DOE/Sandia Responses to NMED's

"Notice of Disapproval: Monitoring Well Plug and Abandonment Plan and Replacement Well Construction Plan Decommissioning of Groundwater Monitoring Well TAV-MW1, Installation of Replacement Groundwater Monitoring Well TAV-MW10, April 20, 2007"

**Monitoring Well Plug and Abandonment Plan
and
Replacement Well Construction Plan**

**Installation of Replacement
Groundwater Monitoring Well TAV-MW10**

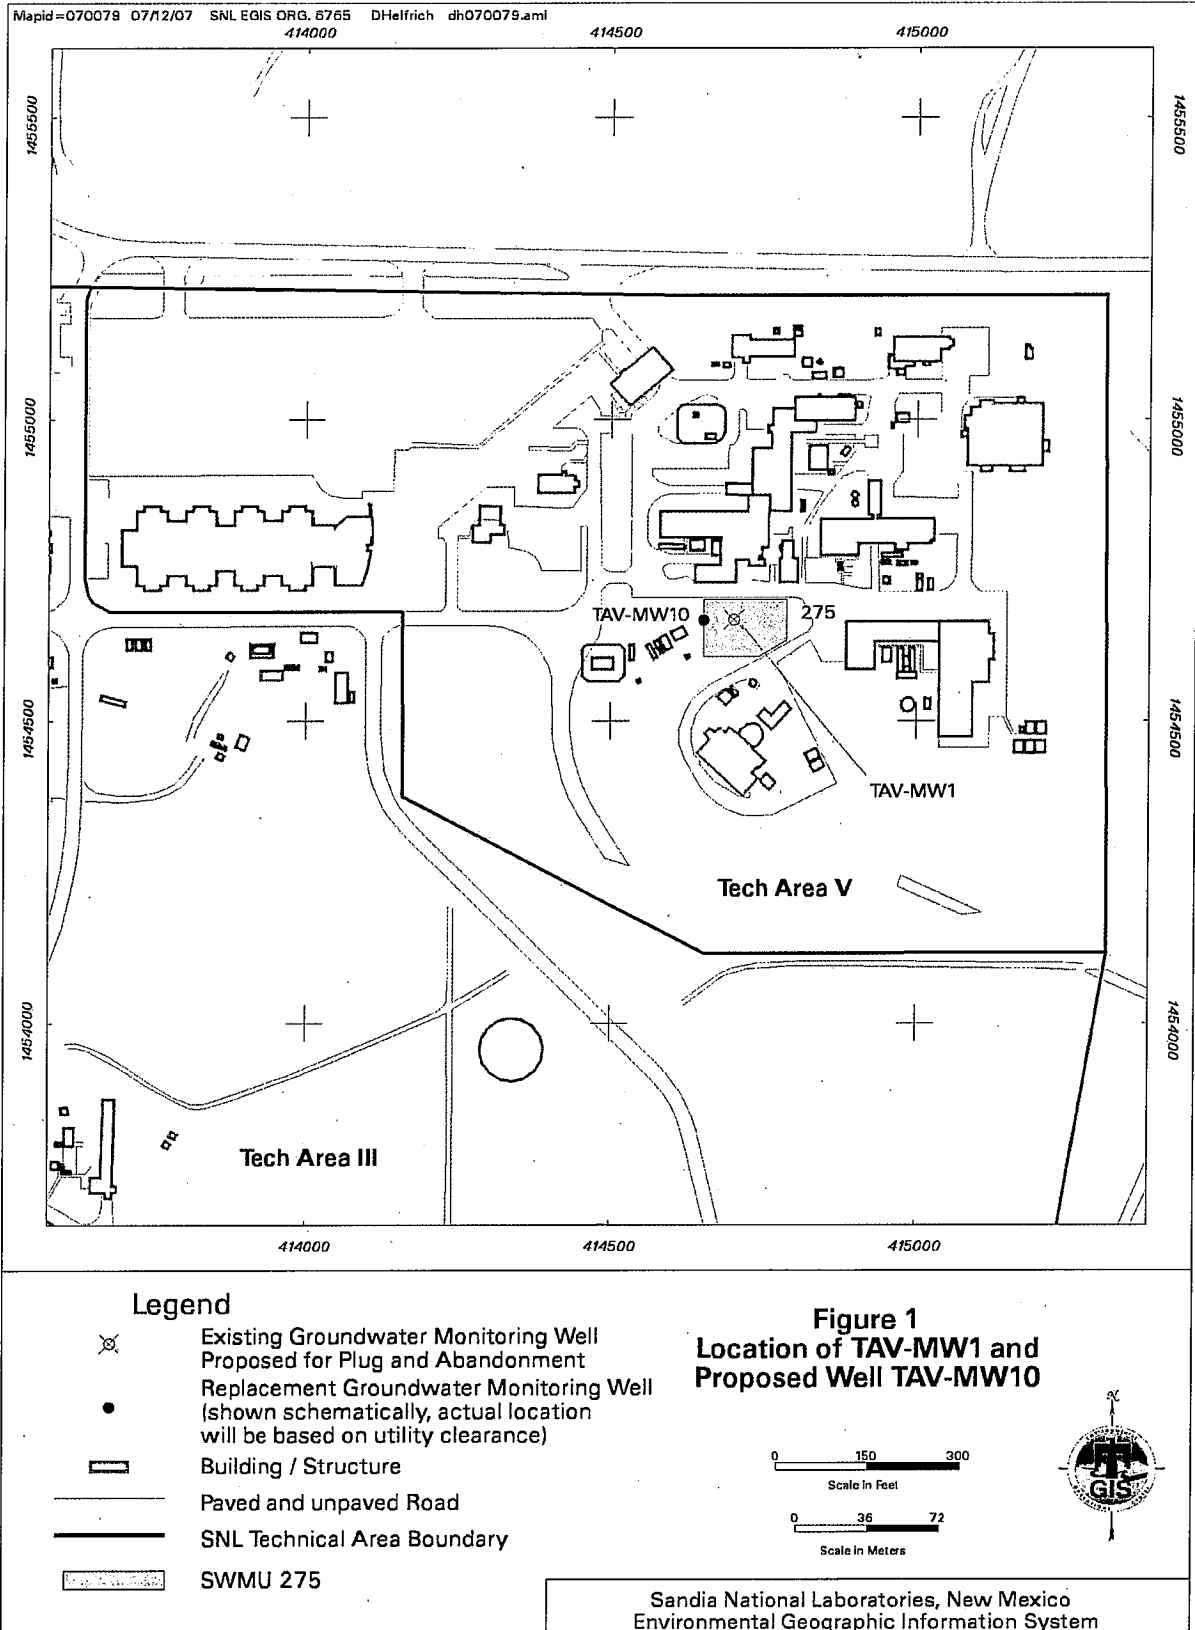
1. Page 5, Section 5.1 – This section states that TAV-MW10 will be installed a minimum of 25 feet away from the existing well (TAV-MW1) location and that the actual location will be selected with concurrence from NMED personnel. The proposed location for TAV-MW10 as shown on Figure 1 is not acceptable to the NMED, as the distance from the existing well is too great. A location no more than 30 feet from TAV-MW1 would be acceptable to the NMED. Modify the plan to indicate the location of TAV-MW10 is to be within 30 feet of TAV-MW1.

Response: It is the intent of DOE/Sandia to install a replacement well as close as practical to the original well. However, deviation logs for existing wells in the vicinity of TA-III and TA-V show that the bottom of a 500+ foot (ft) deep well can commonly be located 20+ ft away (in map view) from the surface completion. To prevent potentially intersecting the existing well DOE/Sandia would prefer to install a replacement well 50 ft away. The shape of the trichloroethene plume in TAV groundwater is well established and relatively stable, such that a replacement well 50 ft away from TAV-MW1 will consistently represent groundwater in this portion of the plume. To further complicate the placement of well TAV-MW10, this portion of TA-V is highly industrialized with a large number of above-ground and underground utilities, and structures that may dictate the location of the well.

With these considerations in mind, this section of the revised *"Monitoring Well Plug and Abandonment Plan and Replacement Well Construction Plan, Decommissioning of Groundwater Monitoring Well TAV-MW1, Installation of Replacement Groundwater Monitoring Well TAV-MW10, Revision 1"* (hereafter referred to as the plan) has been changed and now reads: "TAV-MW10 will be installed at a location approximately 50 ft away from TAV-MW1 (Figure 1), with the precise location determined in the field based on the location of existing above-ground and underground utilities, and structures."

In addition, the location of TAV-MW10 on Figure 1 has been changed to schematically represent a well 50 ft away from TAV-MW1. The legend of Figure 1 reflects that the precise location of TAV-MW10 will be determined in the field based on the location of existing above-ground and underground utilities, and structures.
